Proposed Revisions to a Standard Plans Index

Index Number: 455-002

Index Title: SQUARE PRESTRESSED CONCRETE PILE SPLICES

Sheet1: Updated language in notes and details for clarity.

INDEX 455-002	SHEET 1 of 1
------------------	-----------------

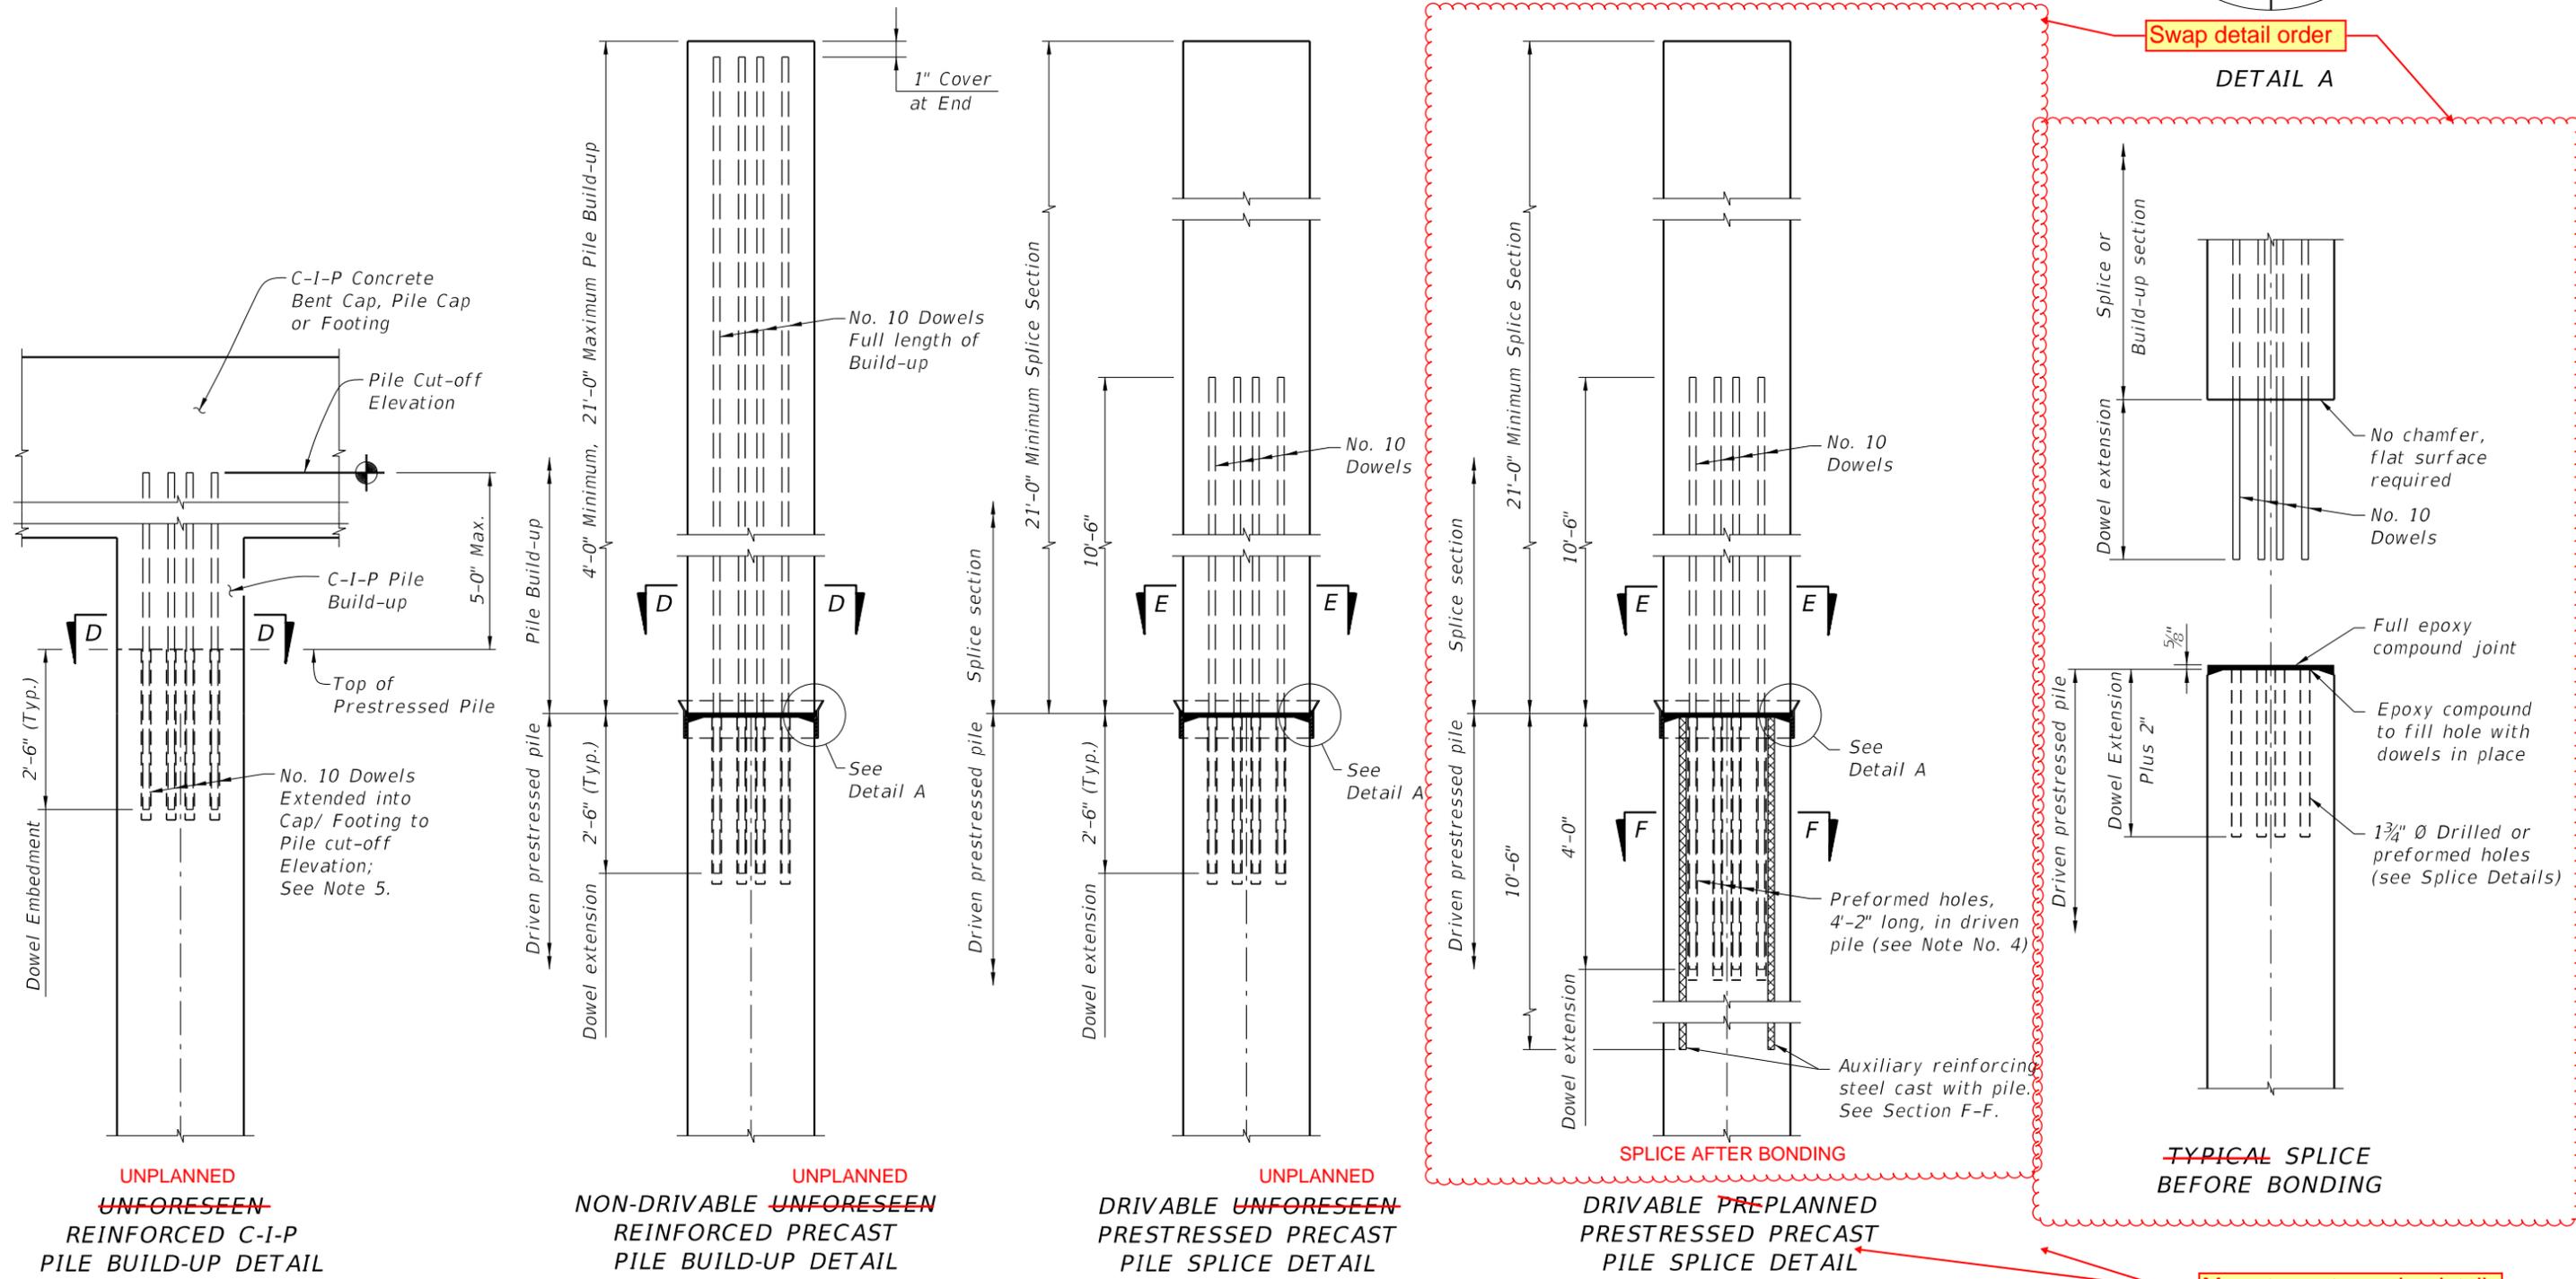
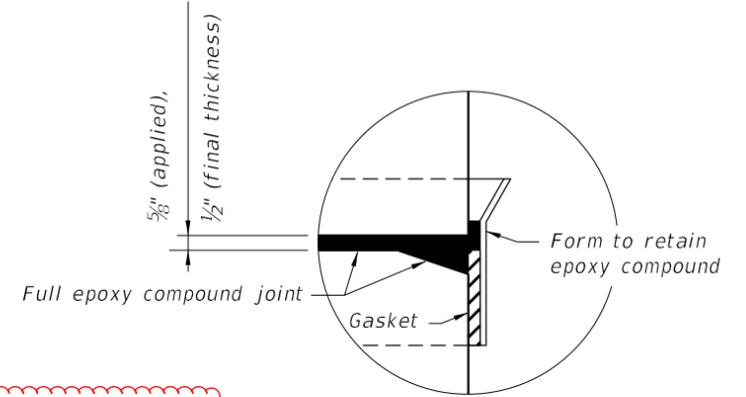
- ~~In cases where pile splices are desired due to length limitations in shipping and handling, the "Drivable Preplanned Prestressed Precast Splice Detail" shall be used.~~
 ~~Mechanical Pile Splices contained on the Approved Products List (APL) may also be used.~~
 When necessary, limitations, use Planned or For preformed

- When preformed dowel holes are utilized, the 1" spiral tie pitch shall be continued to 4'-0" below the head of the pile. See Index 455-018, 455-020 & 455-024. ~~Preformed holes shall utilize either removable preforming material or stay-in-place corrugated galvanized steel ducts. Stay-in-place ducts shall be fabricated from galvanized sheet steel meeting the requirements of ASTM A653, Coating Designation G90, 26 gauge. Ducts shall be 2" diameter, with a minimum corrugation (rib) height of 0.12 in. Ducts shall be fabricated with either welded or interlocked seams. Galvanizing of welded seams will not be required.~~
 Use Specification is ducts
